Work Order ID 91974

Item ID: D412-664-203

Item Name: Crosstube Aft

DRAWING NO. D412-664-243	TITLE CROSSTUBE ASSEMBLY (412 HI AFT)	REV. E	DART AEROSPACE LTD ENGINEERING ORDER		D.E.O. NO. D412-664-243-E-1	SHEET NO. SHEET 1 OF 2	SCALE NTS
DRAWN	CHECKED	MFG. APPR.	APPROVED	DE APPR.			
DATE 11.03.31	DATE 11/03/31	DATE 11.03.31	DATE 11/03/31	DATE 11-03-31

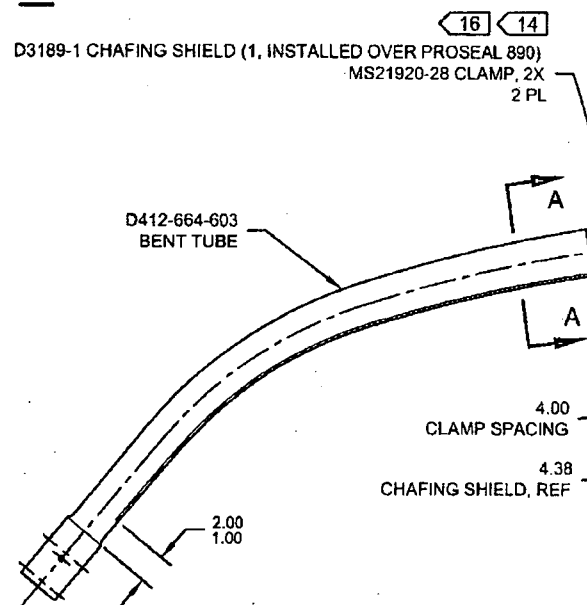
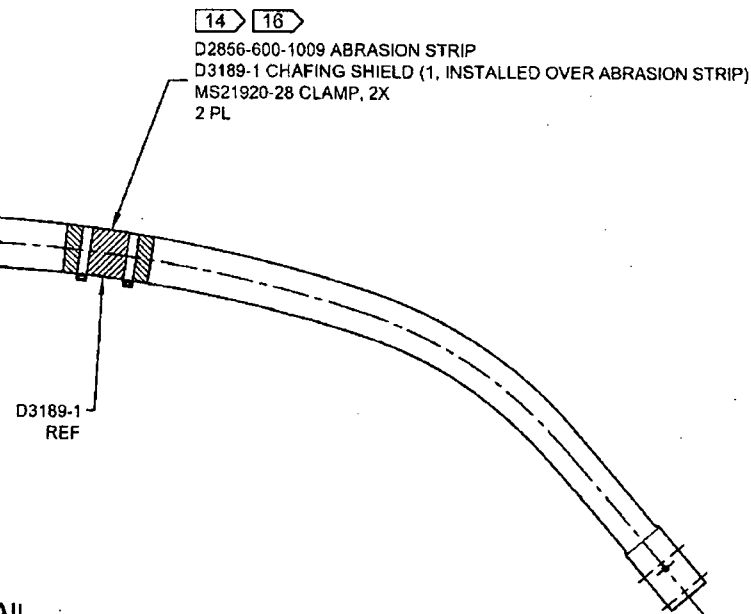
**CHANGE:**

**NOTES 2, 14, AND 16 ON SHEET 1 ARE AMENDED AS FOLLOWS:**

**IS:**

**WAS:**

DRAWING NO. D412-664-243	TITLE CROSSTUBE ASSEMBLY (412 HI AFT)	REV. E	DART AEROSPACE LTD ENGINEERING ORDER		D.E.O. NO. D412-664-243-E-4	SHEET NO. SHEET 3 OF 3	SCALE NTS
DRAWN 92	CHECKED	MFG. APPR.	APPROVED		DE APPR.		
DATE 12.08.21	DATE 12.08.22	DATE 12.08.29	DATE 12.08.29		DATE 12.08.29

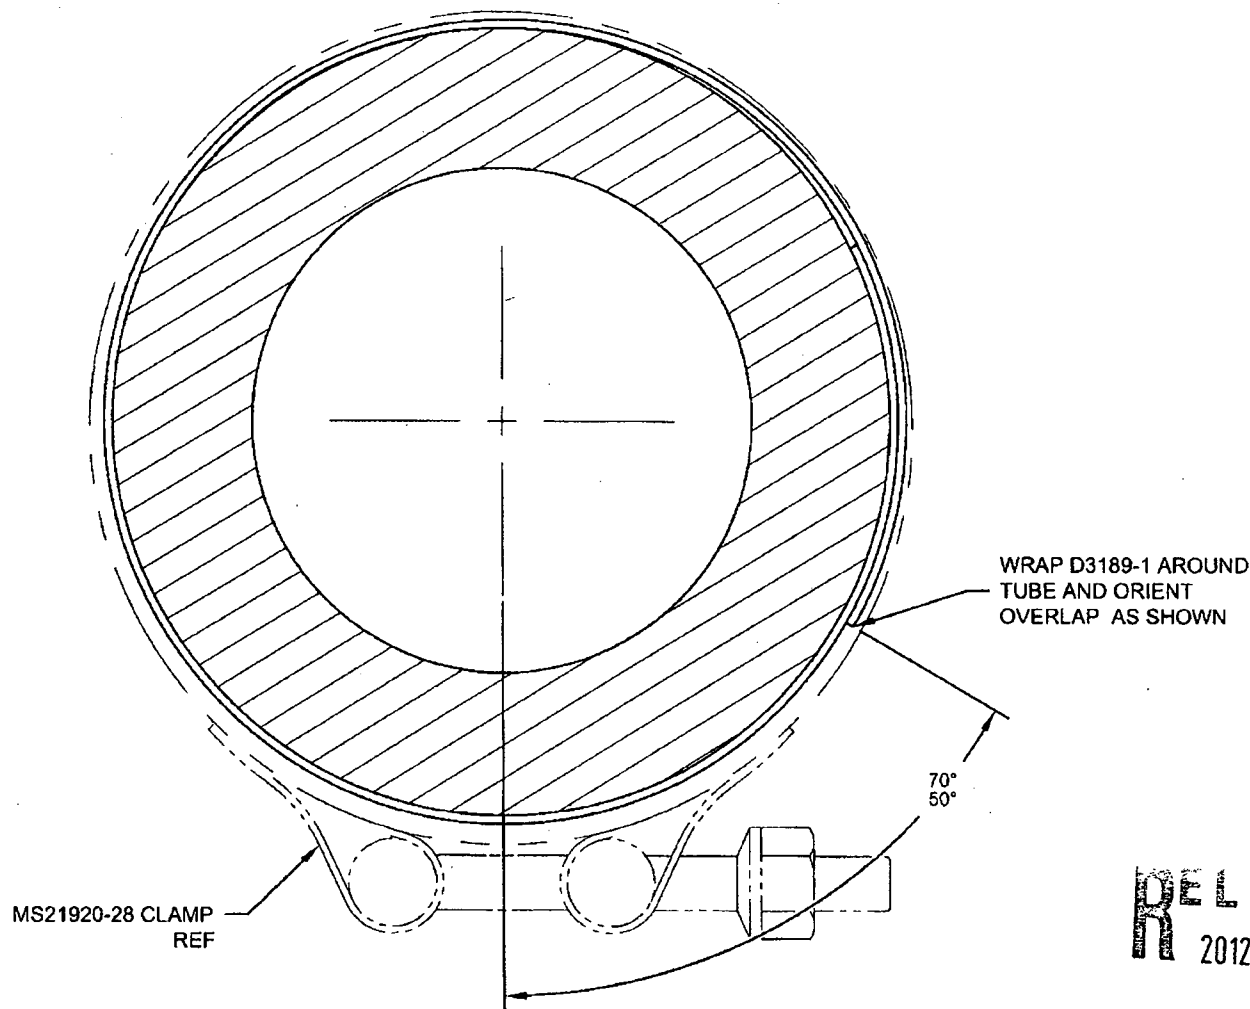
**SECTION A-A**  
CHAFING SHIELD DETAIL  
VIEW ROTATED, NOT TO SCALE
